**Submission on Proposed Plan Change 7 – Rotokauri North Private Plan Change**

## Proposed Plan Change 7 Submission

Figure 15 -7a

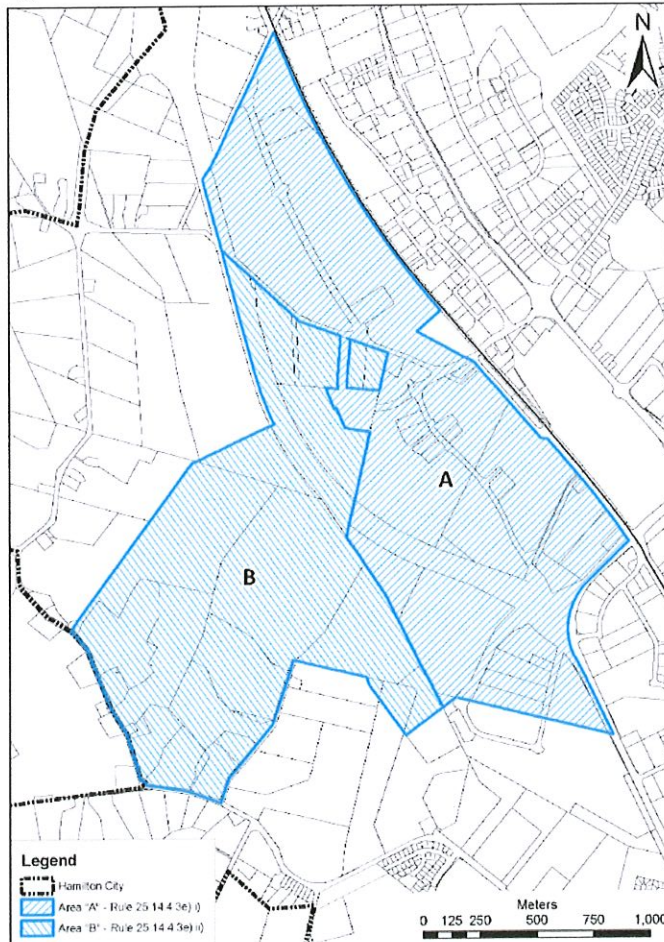
The proposed plan change is inconsistent with structure plan component *“3.6.3.2 Roding”* in its entirety. The proposed area is within the stage 2 area, outside of Areas A and B (see Figure 15-7a). The Rotokauri Structure Plan indicates that the release of land beyond stage 1A (such as the PPC): *“will be contingent upon the availability of network capacity which may arise as a result of traffic generation”* and 3.6.2.3 d and e) provide that:

*Proposals for the development of land in ‘Area B’ on Figure 15-7a will require careful scrutiny to ensure that adequate network capacity exists to support the development, or will be provided as part of the development and they will not compromise the development of land in ‘Area A’ on Figure 15-7a. Development will require:*

e) The development of land outside Areas 'A' and 'B' (Figure 15-7a) will need to coincide with the northwards extension of Rotokauri Minor Arterial Road to connect with Te Kowhai Road at the City Boundary.

The PPC is clearly contrary to these provisions, and the developer is trying to dodge the full cost of developing ahead of the planned sequencing by exempting itself from these Rotokauri Structure Plan provisions. The PPC does not provide adequate transport network capacity outside of the PPC area to support the proposed development. The proposal does not achieve a sustainable expansion of the city and does not represent coherent and integrated development, because the transportation effects beyond the Rotokauri North boundaries have not been resolved.

- Either decline the private plan change; or
- Decline proposed inclusion of section 3.6 d (exemption of PPC area from Rotokauri Structure Plan), but approve the development subject to requiring the developer to adhere to all existing Rotokauri structure Plan provisions, including:
  - a) requiring they construct the Rotokauri Minor Arterial Road;
  - b) provide an ITA that adequately assesses impacts on the wider transport network and have that ITA peer reviewed.
  - c) cater for the demand generated within the wider transport network;

- d) requiring the developer to fund all necessary road network upgrades and additions.
- e) provide a full economic assessment of the financial impact on the remainder of the Rotokauri Structure plan area and including the likely cost of the required roading upgrades.
